**Date:** August 7, 2020  
**To:** Planning Board  
**From:** Kellie Walsh, Town Planner  
**Subject:** Chappell Properties, LLC (owner/applicant) – Review for acceptance and consideration of final approval for a major site plan to construct a 6,000 square foot storage building along with associated site improvements. The parcel is located at 32 Old Brookline Road in the Integrated Commercial Industrial District. Tax Map 48, Lot 5.

**Re:      Chapelle Properties Site Plan (Tax Map 48, Lot 5) – Site Plan Review**

# SITE DEVELOPMENT PLANS CHAPPELL PROPERTIES, LLC

**SITE PLAN**  
**TAX MAP 48 LOT 5**  
**(32 OLD BROOKLINE ROAD)**  
**MILFORD, NEW HAMPSHIRE**  
 PREPARED FOR AND LAND OF:  
**CHAPPELL PROPERTIES, LLC**  
 454 NH ROUTE 13 SOUTH, MILFORD, NH 03055-3415

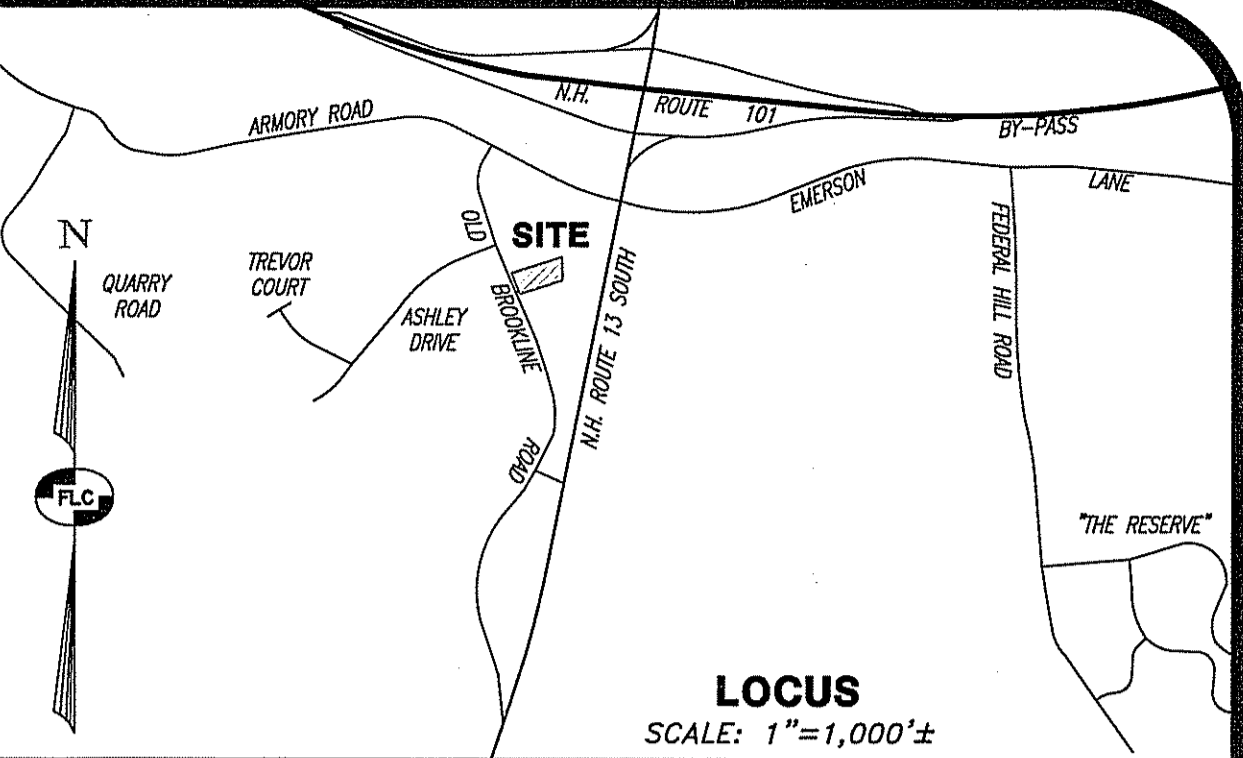
The proposed parking appears to meet the minimum requirements set forth in Section 6.05.4 Table of off Street Parking which requires one (1) spaces per 1,000 square feet: **6,000SF = 6 spaces required**. The plan proposes a gravel parking area which appears to allow for at least 6 spaces; however parking spaces are not outlined on the plan. The applicant should confirm.

1. Site Plan. Parking. Please confirm the gravel parking area can meet the minimum required 6 parking spaces.
